MEDIAN CUT FOR  
GOLDEN CORRAL/  
RICHARD SANBORN  
APPROVED  
WITH CONDITIONS

**TO:** City Council  
**FROM:** City Manager  
**DATE:** May 29, 1981  
**SUBJECT:** Request by Richard E. Sanborn for Median Opening on Cherokee Lane

**TO:** City Council  
**FROM:** City Manager  
**DATE:** December 31, 1980  
**SUBJECT:** Request by Richard E. Sanborn for Median Opening on Cherokee Lane

**CITY OF LODI**  
PUBLIC WORKS DEPARTMENT

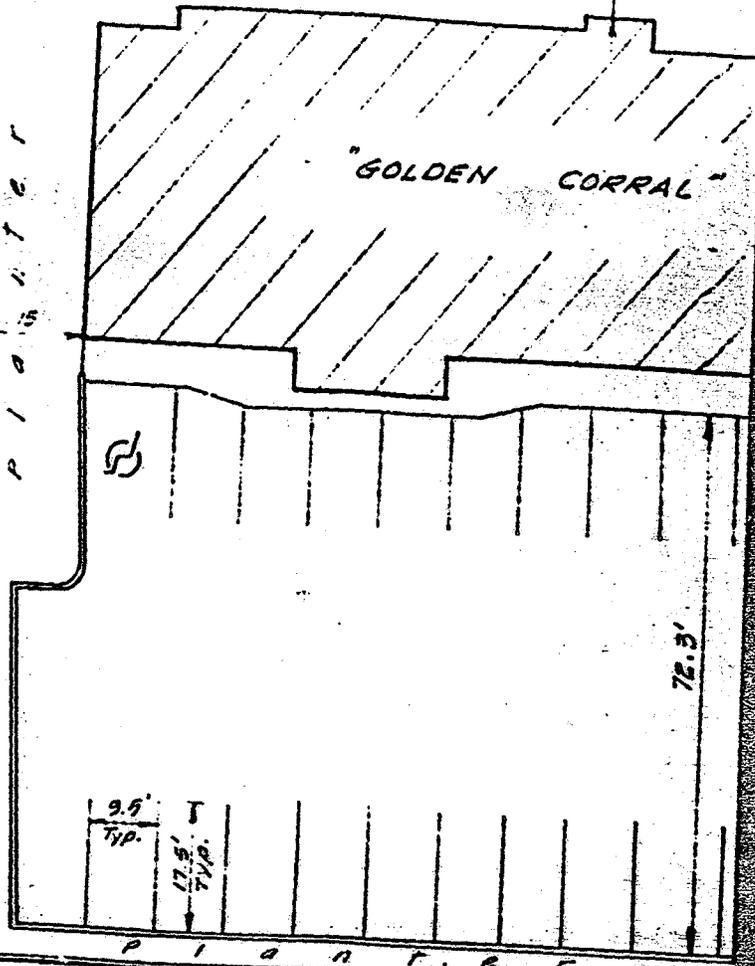
Please note that the driveway request has been modified from one 30-foot and one 35-foot driveway to one 40-foot driveway. If granted, this change in driveways will require a resolution.

This is a formal request to appear before the Lodi City Council for a median opening on Cherokee Lane opposite a 40' driveway to serve Sanborn Chevrolet, Golden Corral Restaurant and open land to be developed at a future date. This median opening is to be paid for by the users. The opening is to be engineered by Baumbach and Piazza and will meet City engineering requirements.

We are also requesting a variance in the City Code to allow a 40' driveway from the standard multi-use 35' driveway. There are truck deliveries that will be made to both businesses. Sanborn Chevrolet presently has truck and trailer rigs entering a 30' driveway and running over the lawn area to complete their turns. The 40' driveway is necessary to allow for the proper turning area for truck traffic and allow other vehicles to exit safely.

Mr. Sanborn was in the audience and addressed the Council regarding his request. A lengthy discussion followed with questions being directed to Staff and to Mr. Sanborn. On motion of Councilman Pinkerton, Murphy second, Council adopted Resolution No. 81-66 establishing new access rights to a parcel of land located at 1190 South Cherokee Lane, Lodi, with the following conditions:

- 1) that Resolution No. 80-150 is hereby rescinded;
- 2) that the design of the median is subject to approval of the Public Works Director
- 3) that all costs related to the median opening to be borne by the parties above listed;
- 4) that this Resolution is adopted on the express condition that property owners of record shall be fully responsible for the cost of installing street
